**Re: Arch Resources, Inc.
Form 10-K for the Fiscal Year Ended December 31, 2023
Filed February 15, 2024
File No. 001-13105**

Form 10-K for the Fiscal Year Ended December 31, 2023

96.2, page 99

Figure 13-1: Lower Kittanning LOM Map

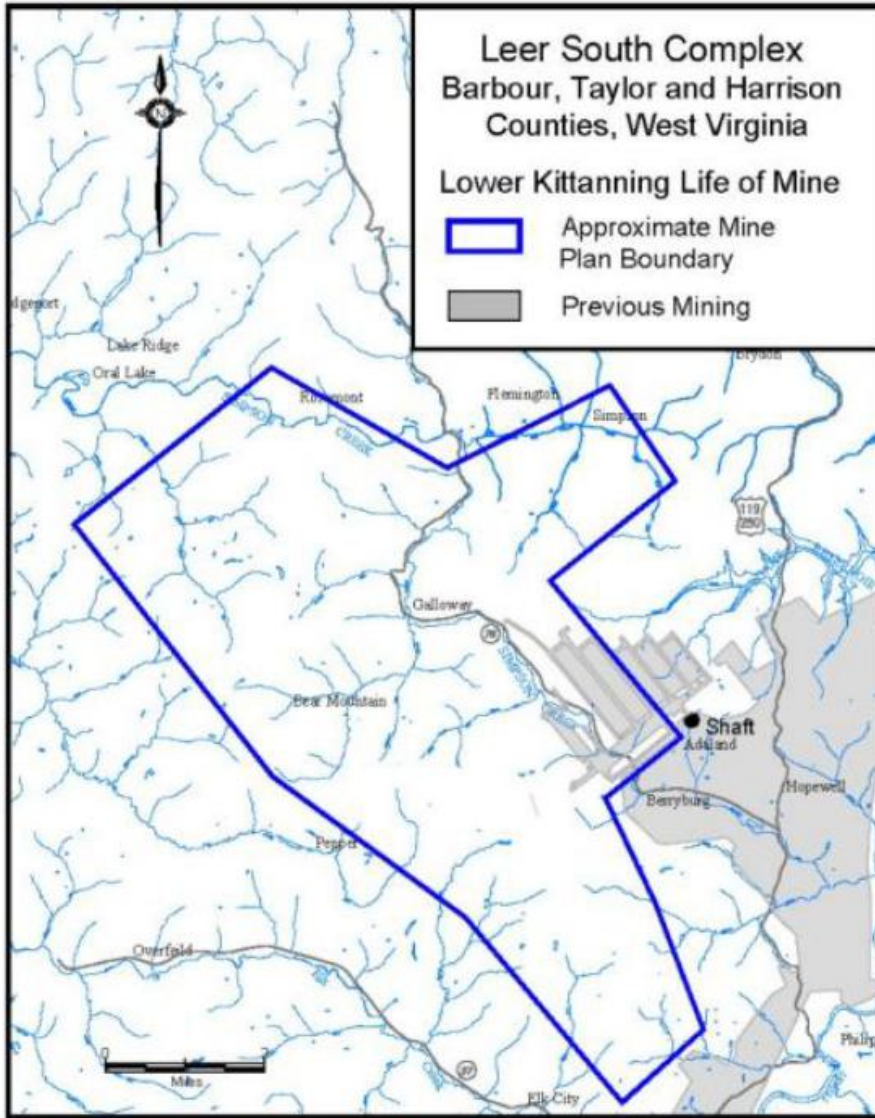
Include Appendix C, which is referenced on page 47 with respect to the footprint of the LOM plan.

We respectfully acknowledge the Staff’s comment. The reference to Appendix C should have been removed from the published version of the TRS. We note that Item 601(b)(96)(iii)(B)(13)(v) of Regulation S-K requires the inclusion of a final map outline, which is included as Figure 13-1 in the TRS. For your convenience, we have inserted the same figure below. We believe this map satisfies the requirements of Item 601(b)(96)(iii)(B)(13)(v) of Regulation S-K. Our QP will remove the reference to Appendix C in future filed TRSs.
